**ASSESSMENT UNDER SEPP (INDUSTRY AND EMPLOYMENT) 2021 and
DEVELOPMENT CONTROL PLAN SECTION A4
DA24/0196 - construction of shop-top housing comprising three levels of
basement carparking, ground floor retail premises and 72 units, pool and
associated vegetation removal (NRPP) at Lot 1 DP 807977; No. 3 River Terrace
TWEED HEADS; Lot 2 DP 807977; No. 5 River Terrace TWEED HEADS; Lot 5
DP 9056; No. 7 River Terrace TWEED HEADS**

Above: Excerpt of Elevations plan showing proposed "River Terrace" signage.

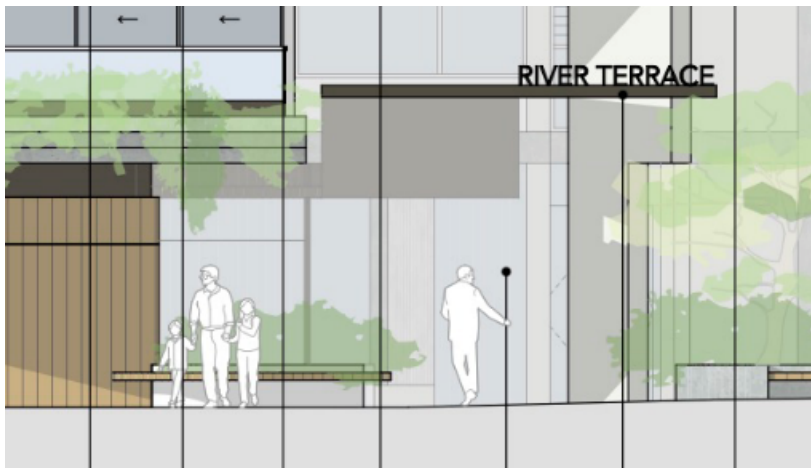
The proposed signage is shown below. The signage measures 0.9m and is identified as a *building identification signage* in the applicant's SEE. The signage is placed above an awning that protrudes into the road reserve. Owner's consent from Council has been received for the application.

Above: Excerpt of Level 01 plan showing proposed awning and signage.

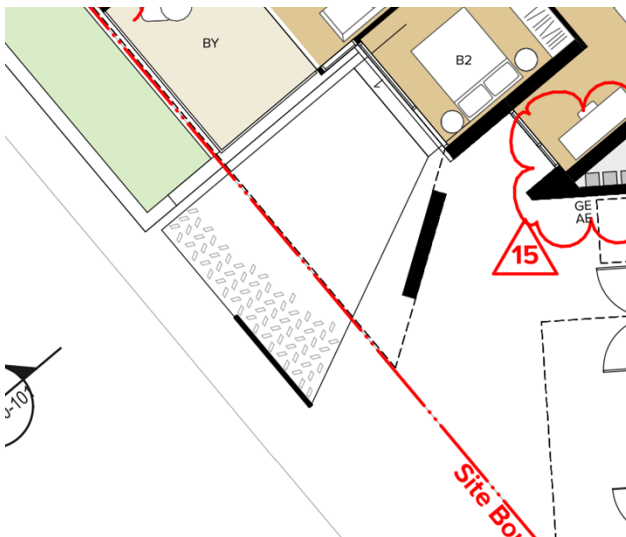
6 Associated devices and logos with advertisements and advertising structures		
16	Have any safety devices, platforms, lighting devices or logos been designed as an integral part of the signage or structure on which it is to be displayed?	None proposed.
7 Illumination		
17-21	Not applicable. No illumination is proposed.	
8 Safety		
22	Would the proposal reduce the safety for any public road?	The application has been assessed and no concerns in relation to the awnings subject to ensuring a minimum 600mm horizontal clearance from the back of kerb (to be conditioned). No concerns
